WinFrog Technical Notice: Time Synchronization

April 11, 2007

Figure 1

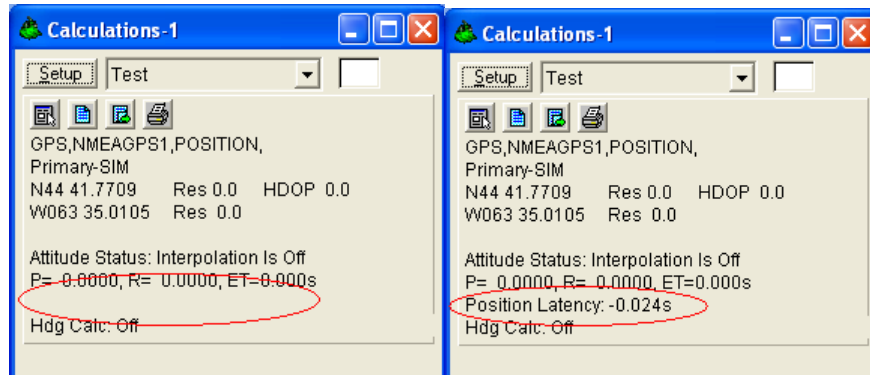
The only place this problem can be observed is in the Calculations Window when displaying the Data Item for a POSITION data item. As a result, it is not apparent in either WinFrog Remote or WinFrog Lite since they do not support Calculations Windows. When the flag indicating that WinFrog is synchronized to UTC is not set, even though WinFrog is actually synchronized, no Position latency is reported (see figure 1). When the flag is set, a position latency is reported (see figure 2).

After launching WinFrog or loading a *cfg* file, open the Configure Time Synchronization dialog and exit by clicking OK.

This bug has been addressed and is now available in version 3.7.9 on our ftp site. Download instructions are as follows:
